Re: Planning Reference 2021/2596/P

**Description: Site R/0 1 Hillfield Road NW6 – OBJECTION TO APP 2021/2596/P
OBJECTION BY 5 HILLFIELD ROAD**

**Site Address: Land between Gondar House and South Mansions, Gondar
Gardens and to the rear of Hillfield Road, West Hampstead, London NW6 1QD.**

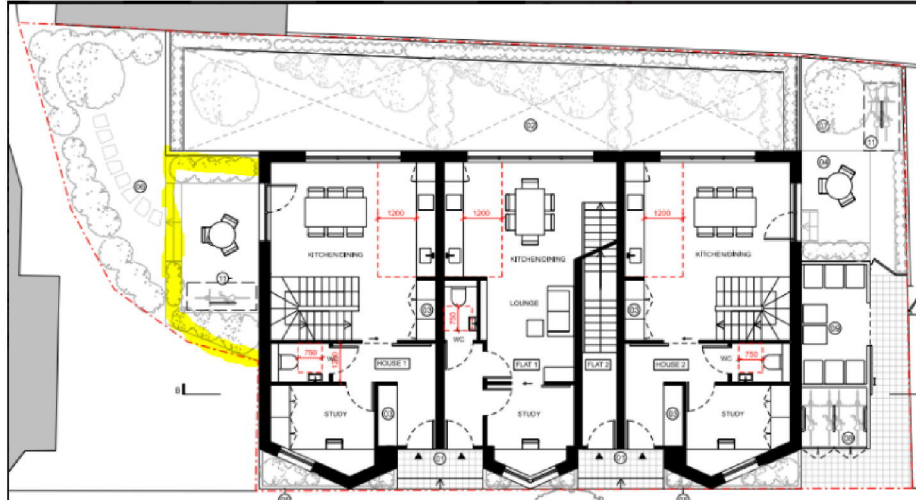
The claim that this is not a garden as it has parking spaces but the building is not built on just the entire parking spaces, an area of about 10sqm as half to the area is occupied by the passage and the bin area. The entire garden is being redeveloped with a new building, lightwell or hard surfaces, only a slither of about **10sqm of the garden will remain at the north part** with south mansion. That is 3% of the garden remaining as a garden. **This is 3% of the 328sqm of the site which currently has about 6% covered with a parking spaces.** Part of the parking space was already designated for bin area and cycle storage with the application of the development of the existing building itself. Below one can see the extent of the built area and the area highlighted in yellow is part of the basement going under the patio area

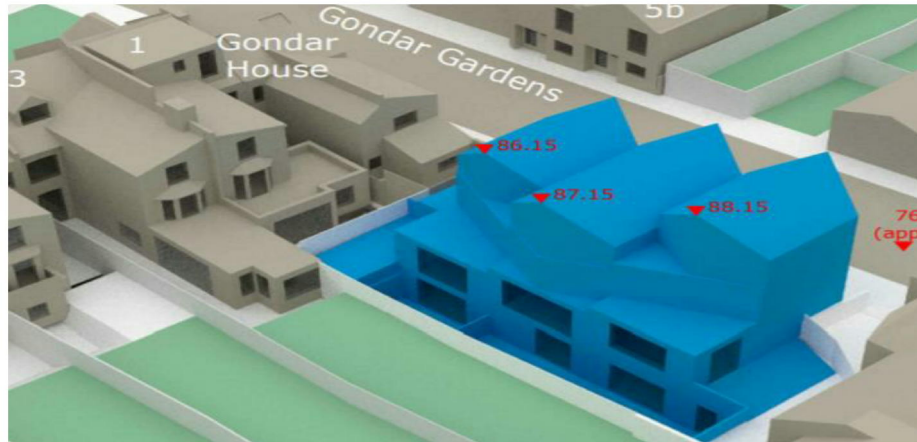
Below drawing submitted by the applicant from the Daylight report clear shows that the current ground floor flat is now completely "boxed in". It is also worth noting that because the garden of 1 Hillfield Road is elevated by more than 1 metre, that with the proposed 2m fence/wall on the side of the newly proposed development, this will result to an unacceptable 3m wall in front of the rear access of the ground floor flat of 1 Hillfield Road.

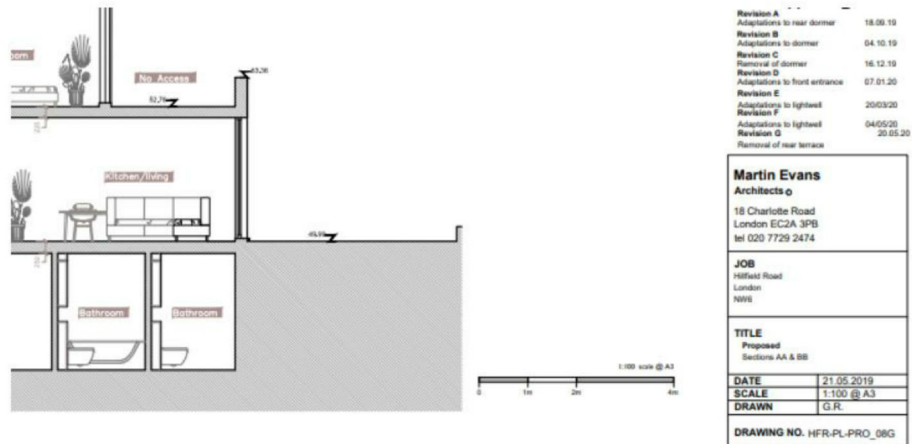
Moreover, the quiet enjoyment of my home and my privacy would also be affected by other negative impacts. My living room windows are situated extremely close to the application site and this development if permitted would negatively impact on daylight and sunlight to my home. I have estimated that the basement of the proposed development would only be **7 metres away** from my home and in consequence I may suffer noise nuisance too, notwithstanding that 3 Hillfield Road is located even closer to the site. The structure itself situated in such close proximity to my flat would be overbearing.
